**PERMIT TRACKING FORM**

Permittee	PacifiCorp	Title of Proposal: <b>Reclamation Activities at the Miller Canyon Portals</b>
Mine Name	Cottonwood/ Wilberg Mine	
Permit Number	ACT/015/019	
Permit Change #	AM99B	Copies Required: 7      Received: 2

**Re: Notice to Conduct Reclamation Activities at the Miller Canyon Portals, PacifiCorp, Cottonwood/Wilberg Mine, ACT/015/019, Emery County, Utah**

**Re: Response to Deficiencies to the Miller Canyon Reclamation Plan, PacifiCorp, Cottonwood/Wilberg Mine, ACT/015/019, 99B, DOGM File #2, Emery County, Utah**

**COTTONWOOD MINE**  
**OVERLAND CONVEYOR**  
**SUBSOIL & NATIVE SOIL STORAGE**

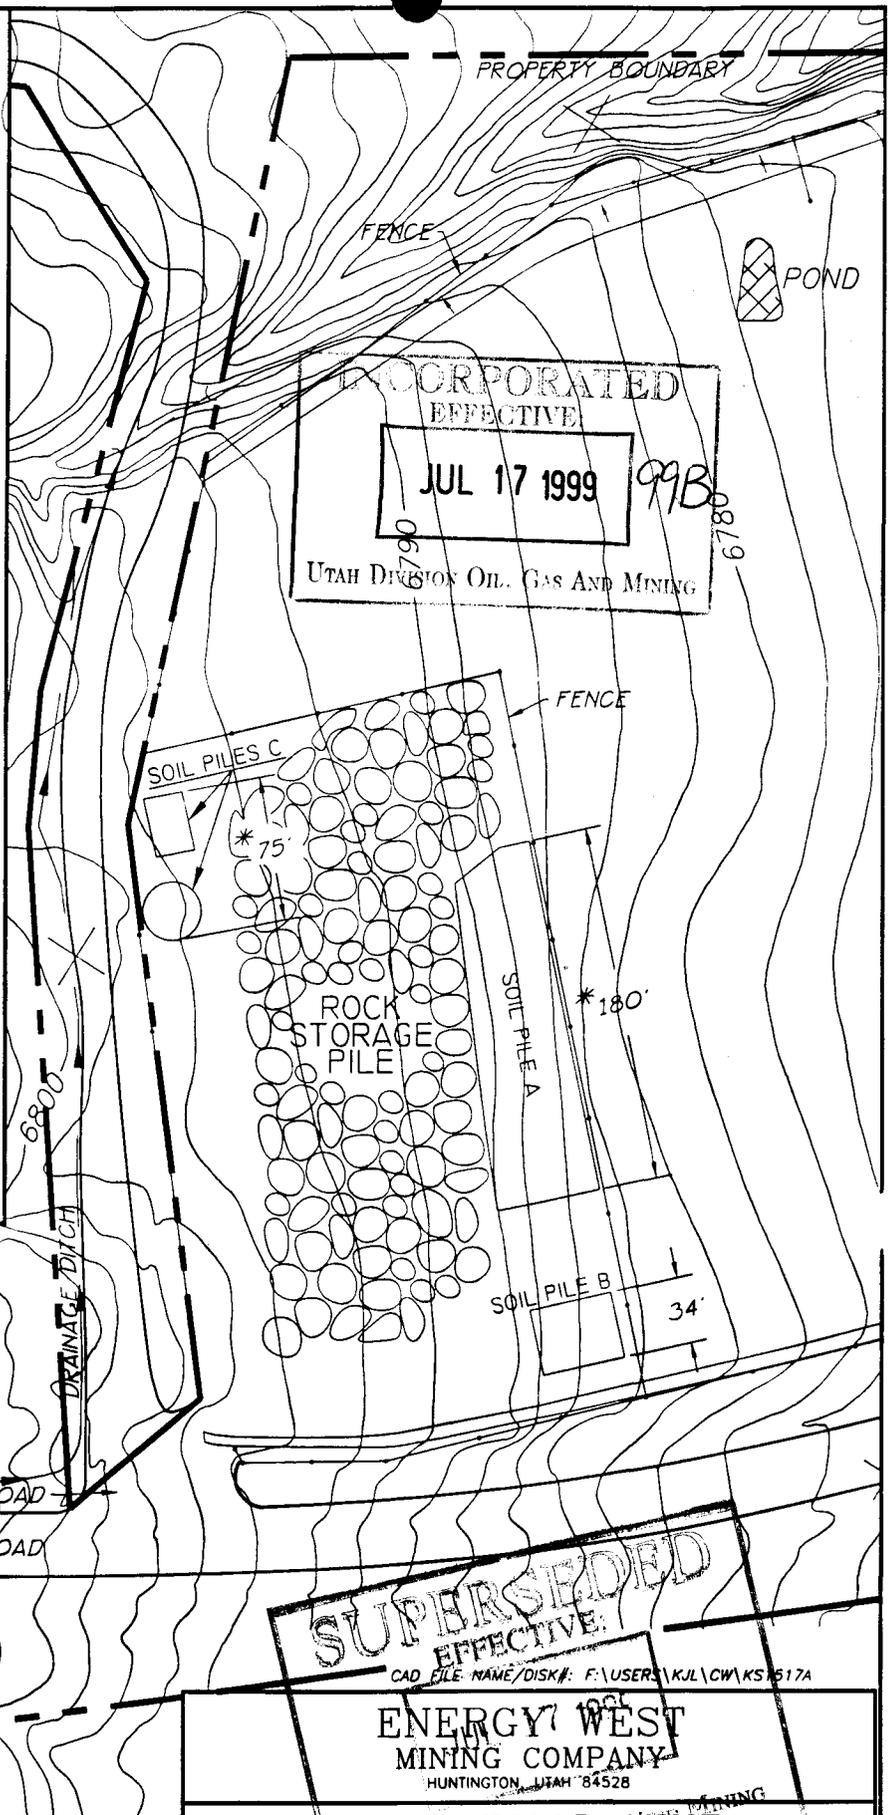
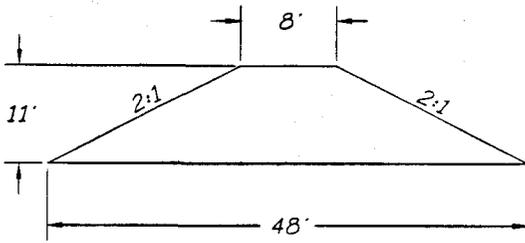
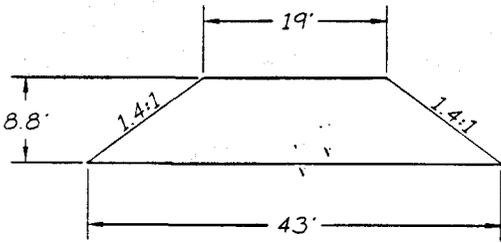
2. **The permittee must provide the following, prior to approval, in accordance with the requirements of :**

**R64-301-223, R645-301-120 and R645-301-130, Please provide Attachment #2 and Attachment #3 as described on page 2 of the submittal and discussed above.**

3. **The permittee must provide the following, prior to approval, in accordance with the requirements of :**

**R645-301-231 and R645-301-120, Please provide a tally in tabular form of the remaining soil stockpiled at the Cottonwood/Wilberg waste rock site.**

*The location map of the soil piles at the Cottonwood/Wilberg waste rock site was inadvertently excluded from Attachment #2. The reclamation plan will be revised to include this map.*

*A table which outlines the volumes of available soil stored at the Cottonwood/Wilberg waste rock site before and after the Miller Canyon reclamation project will be included in Attachment #2 of the reclamation plan. See attachments included at the end of this document.*

CROSS SECTION  
SCALE: 1"=20'

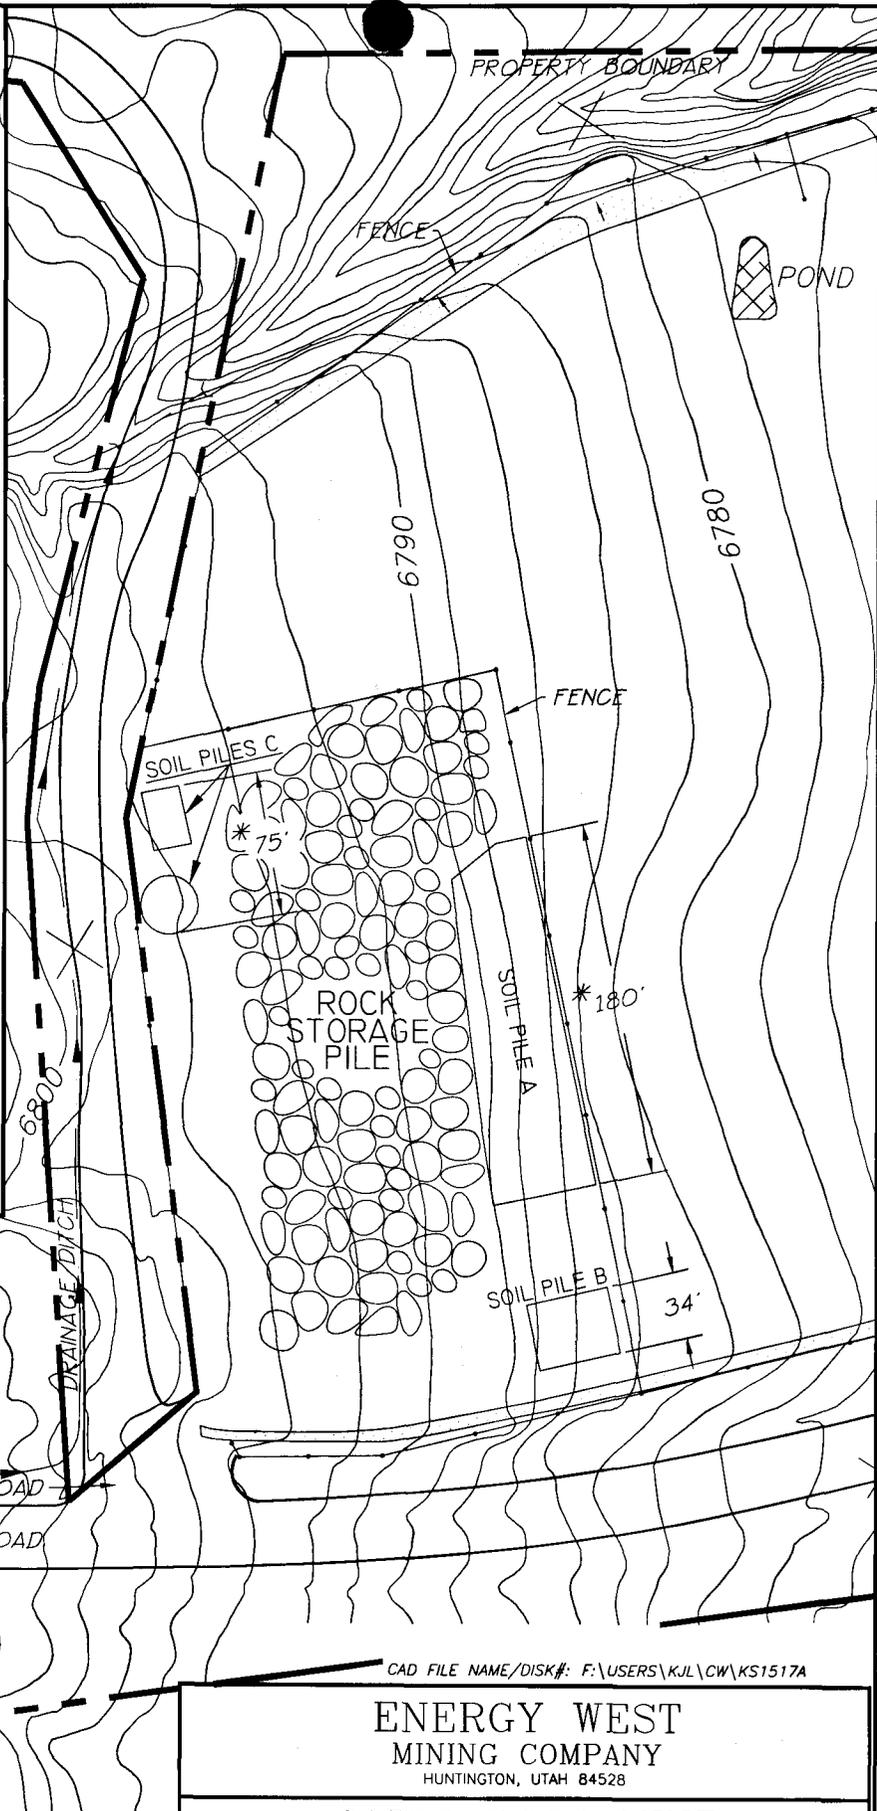
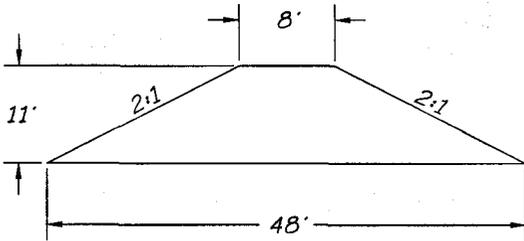
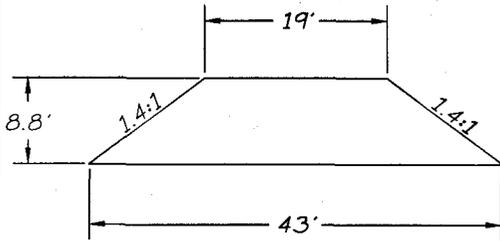
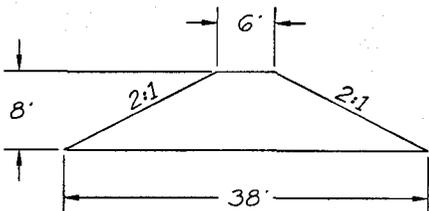
2. **The permittee must provide the following, prior to approval, in accordance with the requirements of :**  
**R64-301-223, R645-301-120 and R645-301-130, Please provide Attachment #2 and Attachment #3 as described on page 2 of the submittal and discussed above.**

3. **The permittee must provide the following, prior to approval, in accordance with the requirements of :**  
**R645-301-231 and R645-301-120, Please provide a tally in tabular form of the remaining soil stockpiled at the Cottonwood/Wilberg waste rock site.**

*The location map of the soil piles at the Cottonwood/Wilberg waste rock site was inadvertently excluded from Attachment #2. The reclamation plan will be revised to include this map.*

*A table which outlines the volumes of available soil stored at the Cottonwood/Wilberg waste rock site before and after the Miller Canyon reclamation project will be included in Attachment #2 of the reclamation plan. See attachments included at the end of this document.*
